Access Compliance Report

Public Rights-of-Way

(Curb Ramps)

Intersection ID: 51062	Main Street: EDDLESTON_AV	Cross Street: TIPPERLINN_WY	Location: SW
ADA ID: 51C02154DB43	Ramp Type: PerpDiag	Initial Pass/Fail: Fail	Overall Compliance: No
		Severity Score: 10

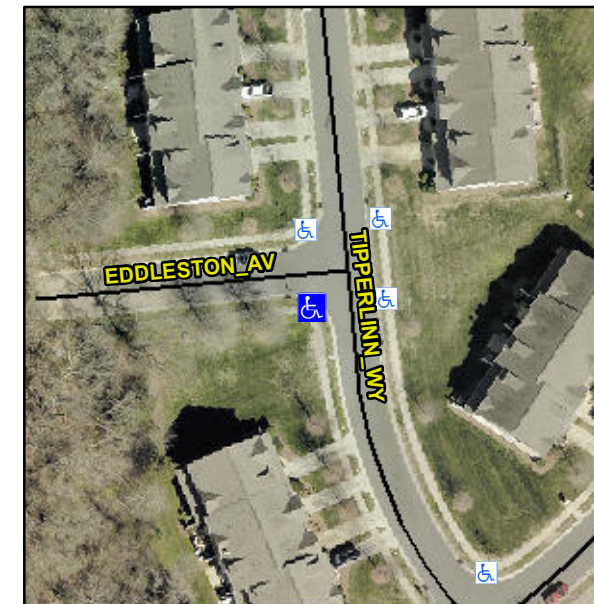
Not Found, R304.5.1, R304.5.3

Compliance	Description	Data	Compliance	Description	Data
N/A	Ramp Length (in)	54.0	Yes	Ramp Slope (%)	6.0
No	Ramp Width (in)	45.0	No	Ramp XSlope (%)	2.9
N/A	Flare Type LT	N/A	N/A	Flare Type RT	N/A
N/A	Flare Slope LT (%)	N/A	N/A	Flare Slope RT (%)	N/A
N/A	Flare Traversable LT?	N/A	N/A	Flare Traversable RT?	N/A
N/A	Landing Length (in)	N/A	N/A	DWS Provided?	N/A
N/A	Landing Width (in)	N/A	N/A	DWS Contrast?	N/A
N/A	Landing Slope (%)	N/A	N/A	DWS Length (in)	N/A
N/A	Landing X Slope (%)	N/A	N/A	DWS Full Width?	N/A
N/A	Landing Curb? (Y/N)	N/A	N/A	DWS Offset (in)	N/A
N/A	Shared Landing?	N/A			
N/A	Gutter Ponding?	N/A	N/A	Gutter Slope (%)	N/A
N/A	Gutter Lip Ht (in)	N/A	N/A	Gutter X Slope (%)	N/A
N/A	Painted X Walk1?	No	N/A	Painted X Walk2?	No
	X Walk 1 Direction	To E		X Walk 2 Direction	To N
N/A	X Walk 1 Width (in)	N/A	N/A	X Walk 2 Width (in)	N/A
	X Walk 1 Slope (%)	6.0		X Walk 2 Slope (%)	2.1
	X Walk 1 X Slope (%)	5.5		X Walk 2 X Slope (%)	1.2

N/A	Ramp inside XWalk1?	N/A	N/A	Ramp inside XWalk2?	N/A
	Road Slope (%)	3.7	N/A	Clear Space?	N/A
	Road X Slope (%)	6.6	N/A	Clear Space to XWalk (in)	N/A
N/A	Any Obstructions?	N/A	N/A	Storm Grate/Utility Hazard?	N/A
	Obstruction Type			Storm Grate/Utility Type	
		N/A			N/A
			Yes	Surface Condition? (G/P)	Good

Remove & Replace Curb Ramp With Two New Directional Ramps or Equivalent.
